United States
Department of
Agriculture

Forest
Service

File Code: 2830

Duhring Resource Company Well sites/road Objections

Warrant 2752/Lot 7

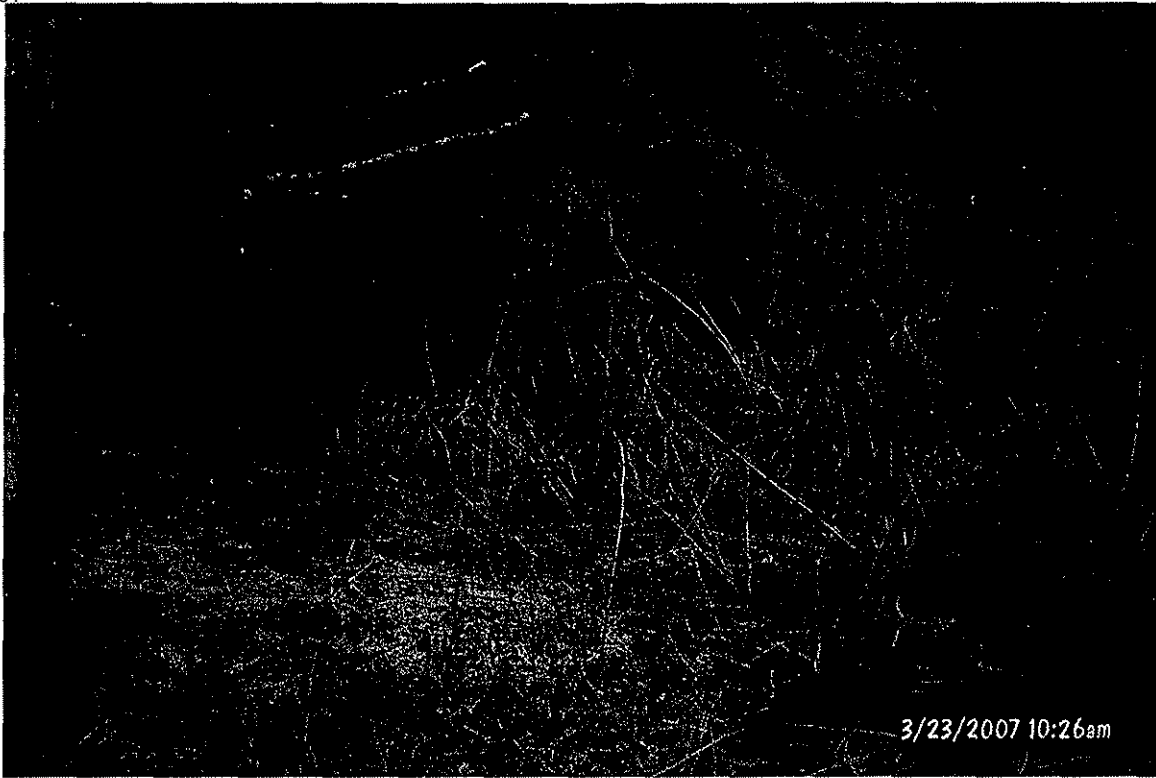
The wells in objection in Warrant 2752, Lot 7, are numbered 7-18, 7-20, 7-21, and 7-22. The Well (Farm) name is Lot 7 and is located within the Sheffield and Ludlow Quadrangles. The well plats for the objected wells were submitted to the Bradford District Office on March 20, 2007. As proposed, Well 7-18 and the access road would directly impact the North Country National Scenic Trail (NCNST) as administrated by the National Park Service. The NCNST was federally designated as a National Scenic Trail in 1980 under Public Law 90-543. Wells 7-20 and 7-21 are proposed within large spring seeps (wetlands) that drain directly into a wetland west of SR 948. Well 7-22 is proposed within this wetland. Please see the attached pictures.
